## **Great North Road Solar and Biodiversity Park**

Written Summary of Oral Submissions from Issue Specific Hearing 3 and Responses to Action Points

Document Reference – EN010162/APP/8.26

February 2026

### *Visual Receptor Group G: East of A1*

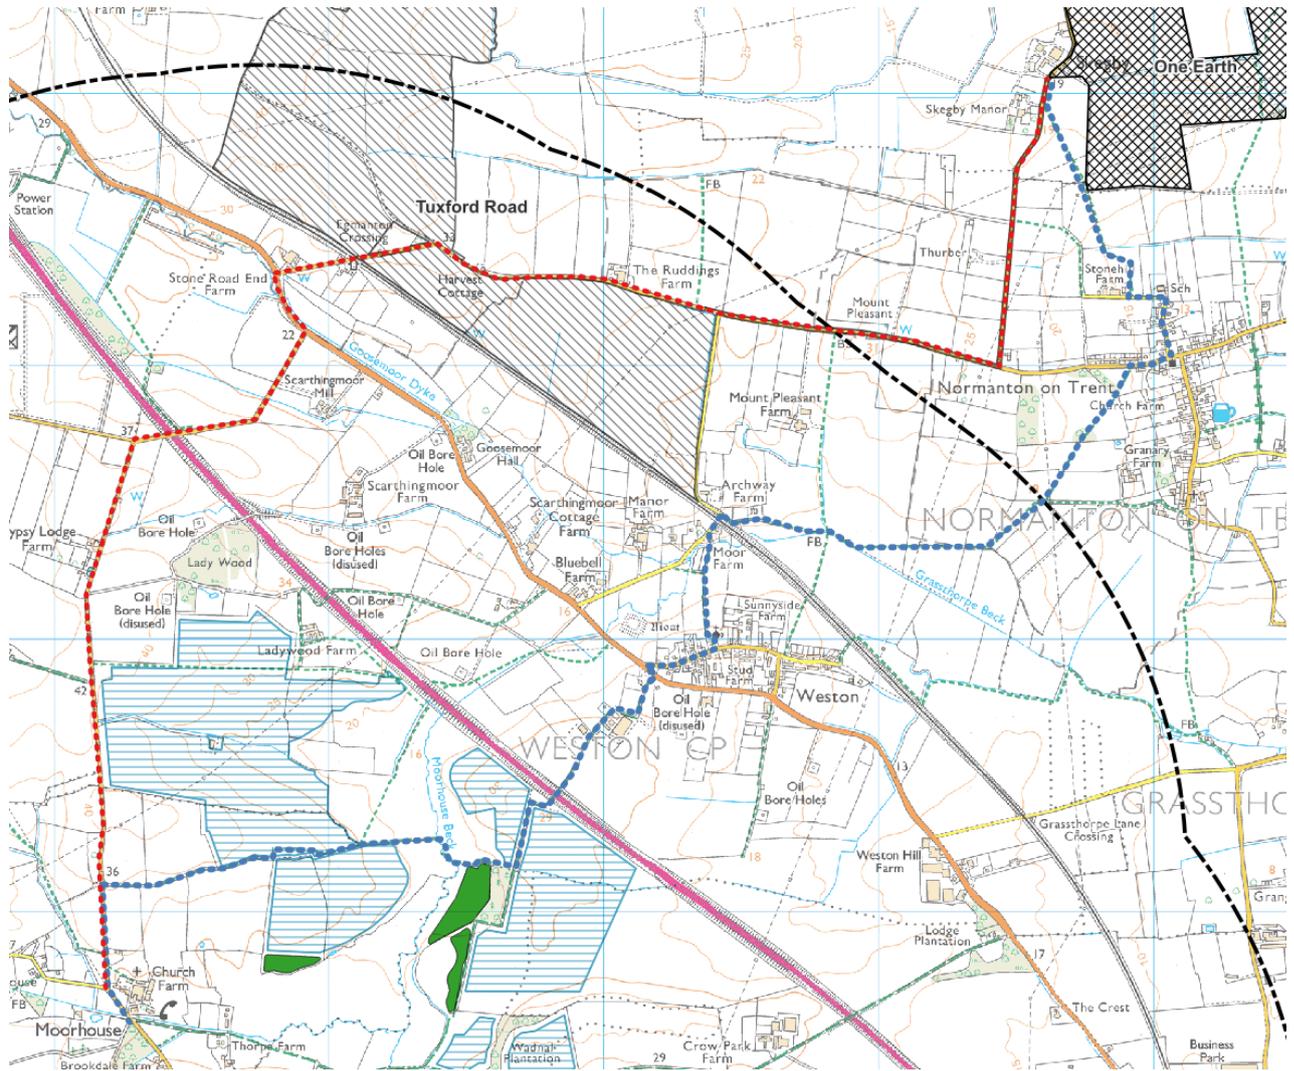
- 1.3.12 As can be seen by comparing the versions of Figure 6.6 and 6.7 provided at the PEIR stage with those provided for the EIA in **ES Volume 3, Figure 7.4 Landscape Character and Visibility [EN010162/APP/6.3.7A] [AS-035]**, there would be very limited visibility of the Proposed Development from the landscape within 1km of the Site and close to Tuxford Road solar farm and the effects would remain the same in this area. There would be visibility of the Proposed Development from the footpaths and local road near Mount Pleasant Farm and Ruddings Farm as illustrated by Viewpoint 52. Given the distance (1.5-2 km) and intervening features in the landscape effects would remain Negligible scale in this area in the absence of Tuxford Road solar farm.
- 1.3.13 Effects would be the same as set out within the **ES Volume 2, Chapter 7: LVIA [EN010162/APP/6.2.7A] [REP2-022]**.
